# PONTIAC

## Service Craftsman News

No. 6 S-284

June, 1956

Fig. 3 Strato-Flight Front Pump Locating Screw

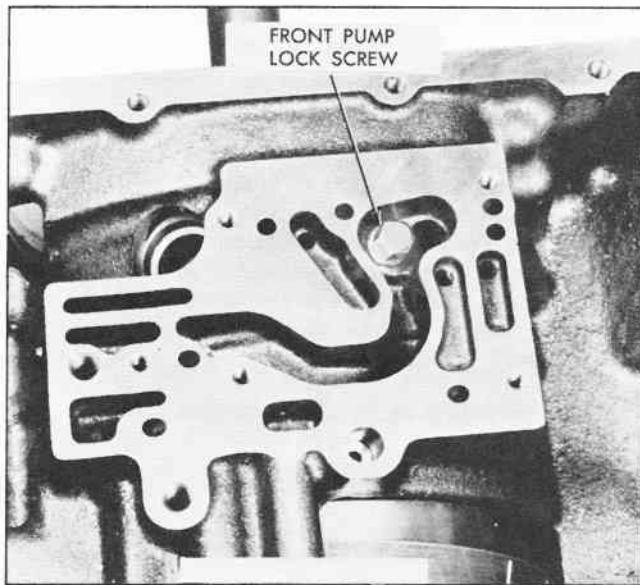
First production Strato-Flight Hydra-Matics had a lockwasher on the front pump lock screw. It was later felt that the lockwasher was undesirable since its sharp edges could shave off metal particles which would circulate with the oil.

A new washer head screw is now being used in production in place of the original screw and lock-washer (Fig. 3). The new screw is available under part number 8617629. Any time an early type lock screw having the separate lockwasher is removed in servicing a transmission, it should be replaced with the new washer head screw.
